# AGENDA ITEM 6

2015/0394/DET

# REPRESENTATIONS

**Planning applications for development of 53 total no. dwellings on land north of Beachen Court, Grantown on Spey. (Ref. 2015/0394/DET and 2015/0402/DET)**

View from The Dulaig driveway looking west to Revoan with the river terrace slope to the left

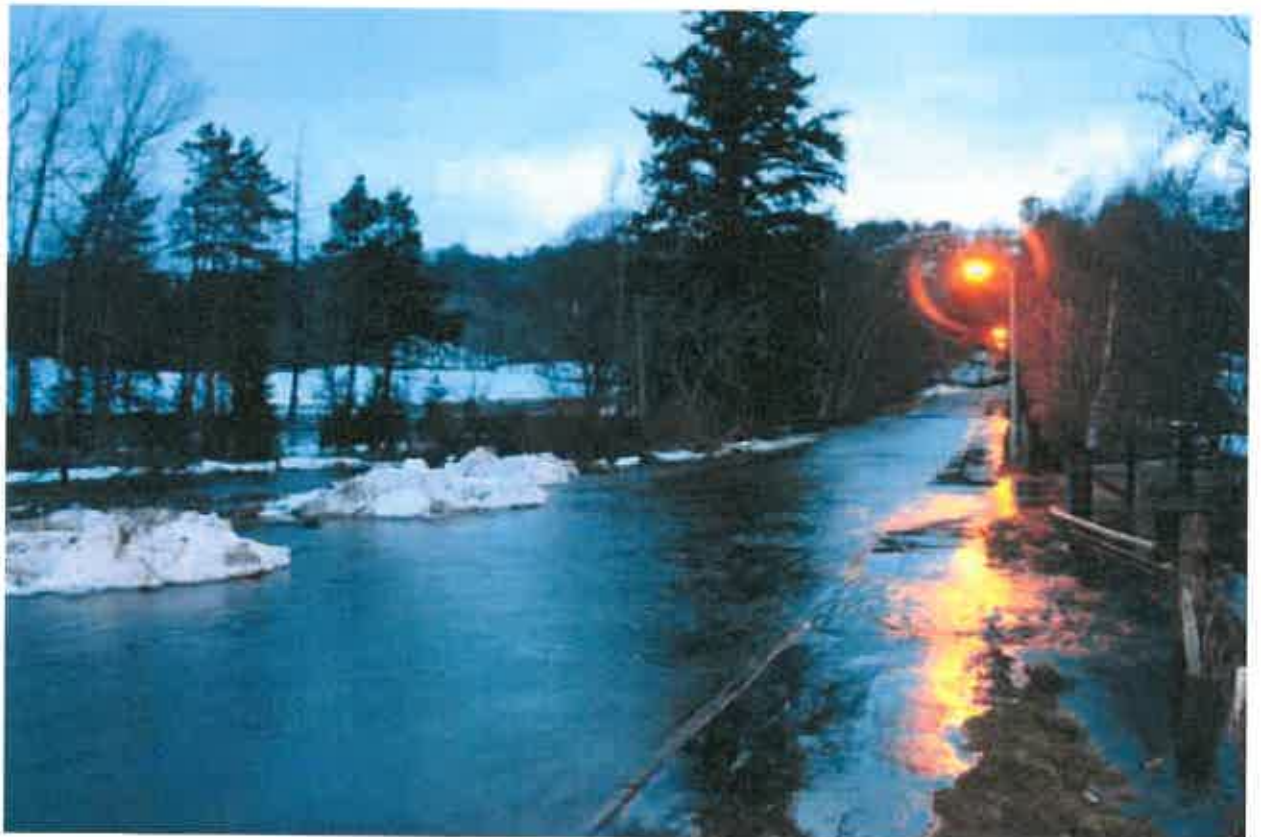
12. I have real doubts over the accuracy of figure 3.1 (and thus, implicitly, the accuracy of figure 4.2 and the whole basis behind the FRA modelling). My doubts are based on my actual observations of several flood events in that area. I attach below photos I took of the flood event of the floodplain area between Revoan and The Dulaig's driveway on the evening of 5 April 2010 around 20.30.

View from the bridge on The Dulaig's driveway, looking up the burn to Revoan. Note the significant flooding to the right (north side) of the burn.
